# CITY OF SAN ANTONIO

Re: Laurel Canyon (Amendment)

MDP # 761-A

**LAUREL CANYON SUBDIVISION**  
MASTER DEVELOPMENT PLAN # 761A  
FEBRUARY 2005

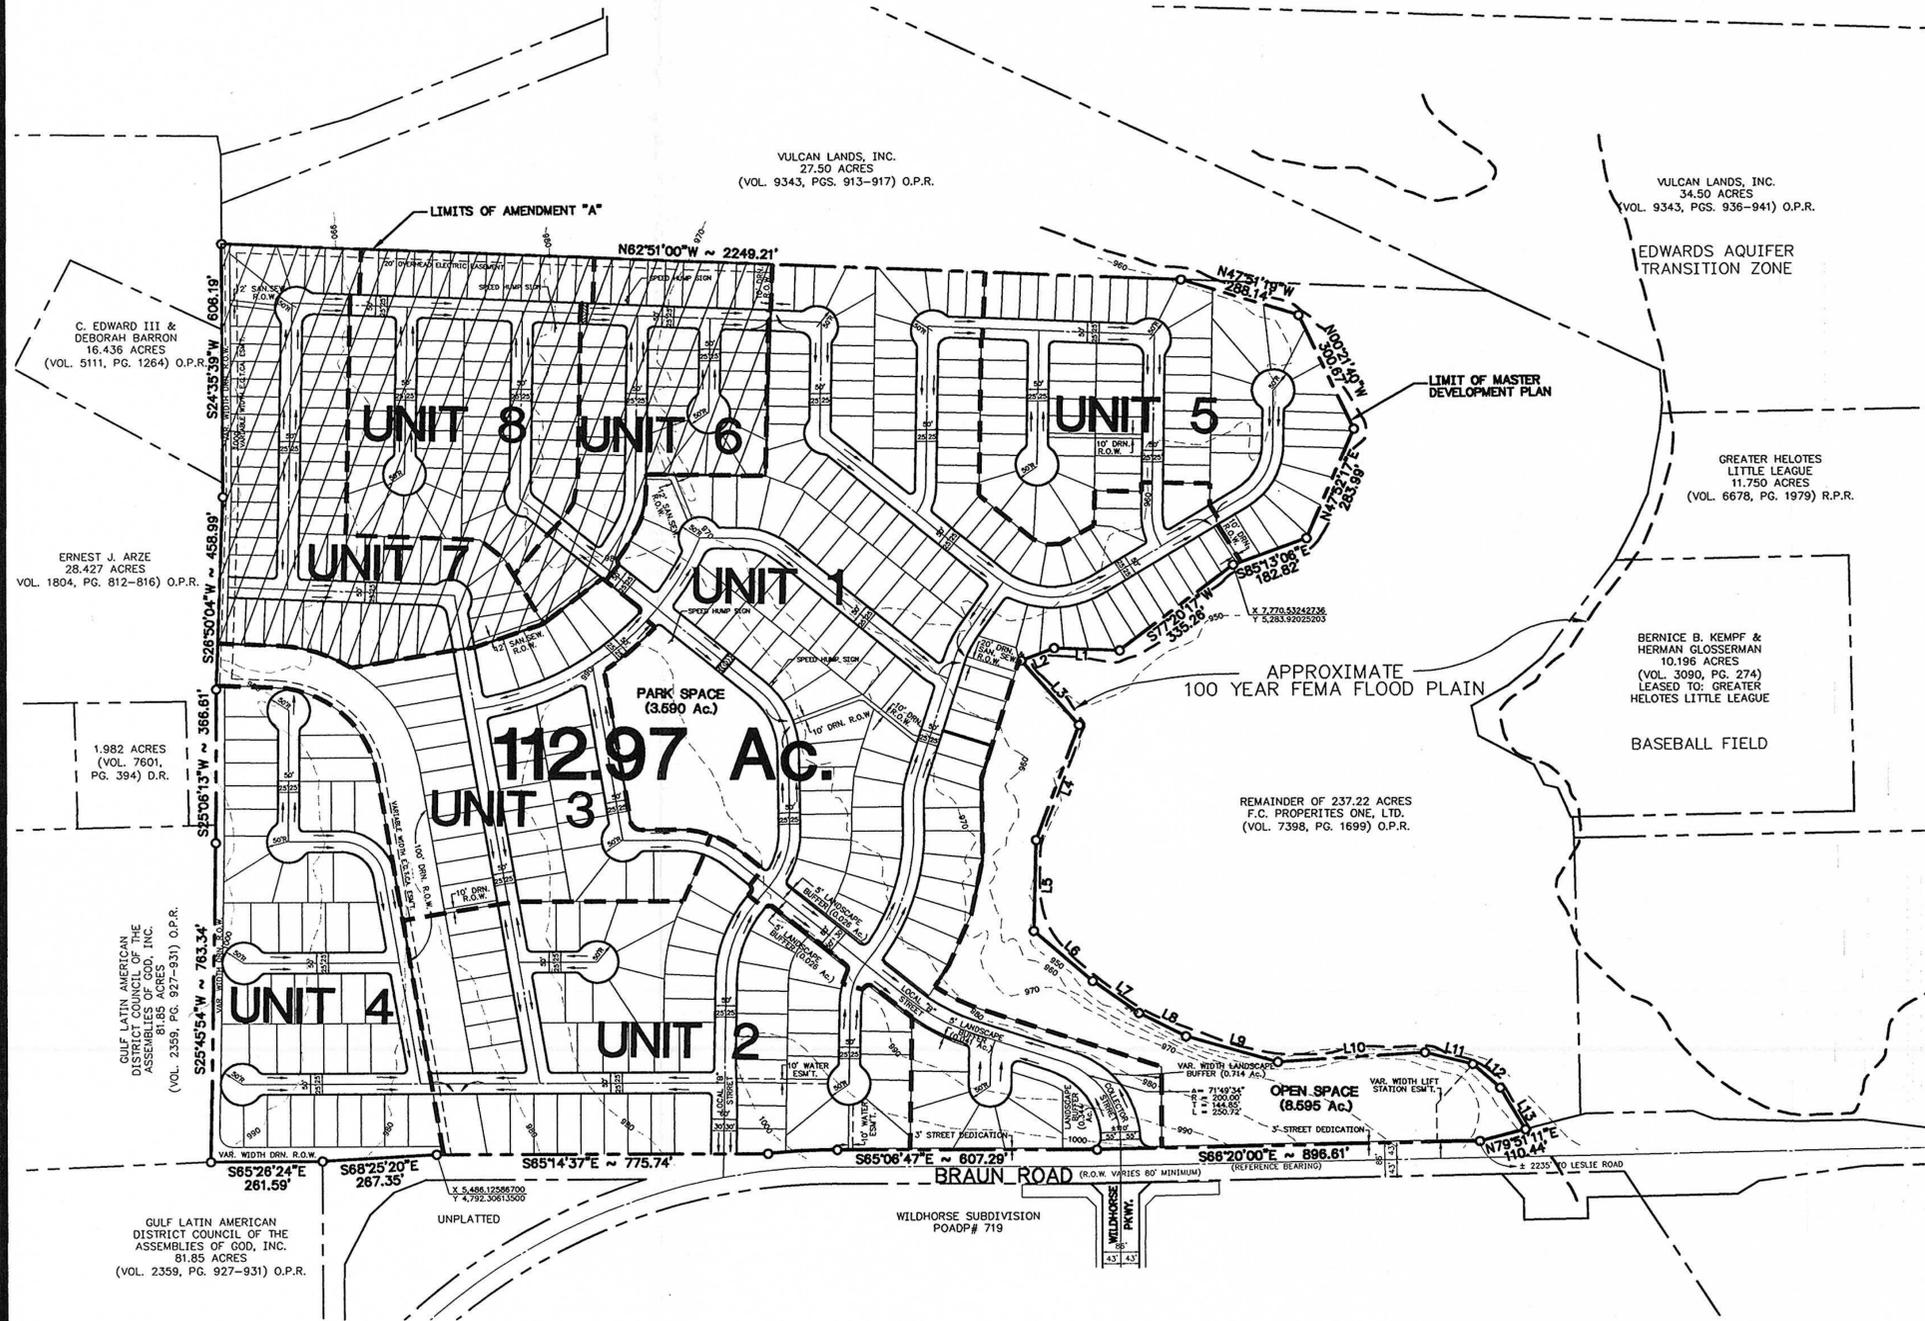
In our brief look at the plan, we saw several problems on the MDP. The liability for any damages caused by the subdivision to downstream properties and any damage caused to the subdivision itself due to drainage deficiencies, remain the sole responsibility of the developers of the property.

In our brief look at the plan, there are several concerns relating to traffic and the impact this subdivision will have on the surrounding area. Due to the deficiencies of the layout, any Traffic issues remain the sole responsibility of the developer of the property.

- In consideration of public safety and convenience, excessive grades by reason of topography should be avoided in street layouts and arrangements.
- This development will need to comply with tree preservation ordinance #85262. For information about these requirements you can contact Tree Preservation at 207-1111.

Laurel Canyon is a subdivision of 529 units. Based on Section 35-503 of the UDC, the park dedication requirement for this development is 4.8 acres.

1. The 3.59-acre park designated "Park" on the plan be deeded to the Laurel Canyon Home Owner's Association (HOA). All requirements of 35-503(f)(2) are in force and required for this park.
2. Trees shall be planted parallel to all perimeter rights-of-ways. The distance between trees shall be an average of 32.5 feet with no distance greater than 50 feet. Each tree must have a minimum caliper of three (3) inches. Applicant may plant a minimum of two of the following species: Cedar Elm, Live Oak, or Monterrey Oak. Trees must be cared for and maintained by the developer for a minimum of one year.
3. The applicant shall install eight (8) picnic units and eight (8) park benches in the Park. Each unit must consist of a picnic table, benches, cement slab, and garbage receptacle. Tables and benches must be concrete or metal.

4. The applicant shall install an Open Play Area. This area is to be a minimum of 20,000 square feet of contiguous, unobstructed space with a maximum slope of five (5) percent. Common Bermuda shall be established in this area. The width of the play area must be a minimum of 100 feet.

5. The applicant shall install utilities to include security lighting and either irrigation for the care of the trees or a water fountain.
  6. The applicant has requested and will receive 1.50 acres credit for the installation of a jogging trail with a minimum length of 0.25 mile meeting the requirements of Table 503-4.

7. Park to be constructed and improved with the development of Phase 1 of the subdivision.
- It will be expected that you will plat all of the property depicted in your Master Development Plan (M.D.P.) to include floodplains, drainage areas and open space.

1. For streets 1200' feet or longer, traffic calming is required.
